## 6. TRAFFIC SAFETY

*For the applicant; WBerksC; WokBC; RBC; RBWM; BFC; BCC; SBDC; SBC; LBHill; LBHouns; GLA; RAC; AA.*

**Figure 1** - Comparison of risk of different operating regimes<sup>1</sup>

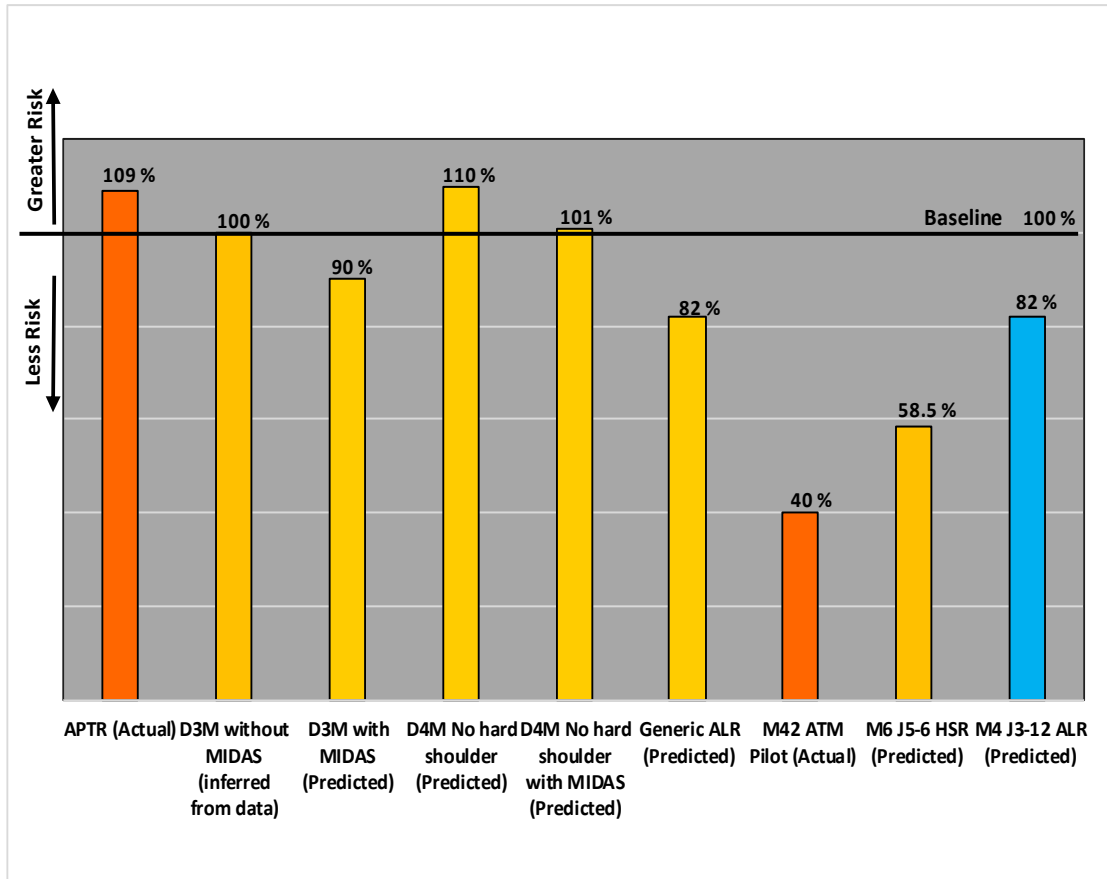
**TS6.4 Can the applicant please provide a table to represent a comparison of hazards in the following scenarios: the application project; the current operation of the M4; the M4 as a Managed Motorway (as in M42 MM); and generic ALR?**

4. Figure 1 shows a comparison of the level of safety benefit following hazard analysis for each operating regime.

5. The graph in Figure 1 shows that a generic ALR scheme is expected to provide a safety benefit of 18% when compared to a generic baseline (a D3M without MIDAS).

6. Figure 1 shows that the M4 J3-12 Scheme is expected to provide a similar safety benefit of 18% to that experienced with a generic ALR scheme compared to a generic baseline. It also shows that the Scheme is expected to provide an 8% reduction in risk when compared to the existing M4 motorway (D3M with MIDAS between J3 to 4 and 5 to 12 and D4M with MIDAS from J4 to 5).
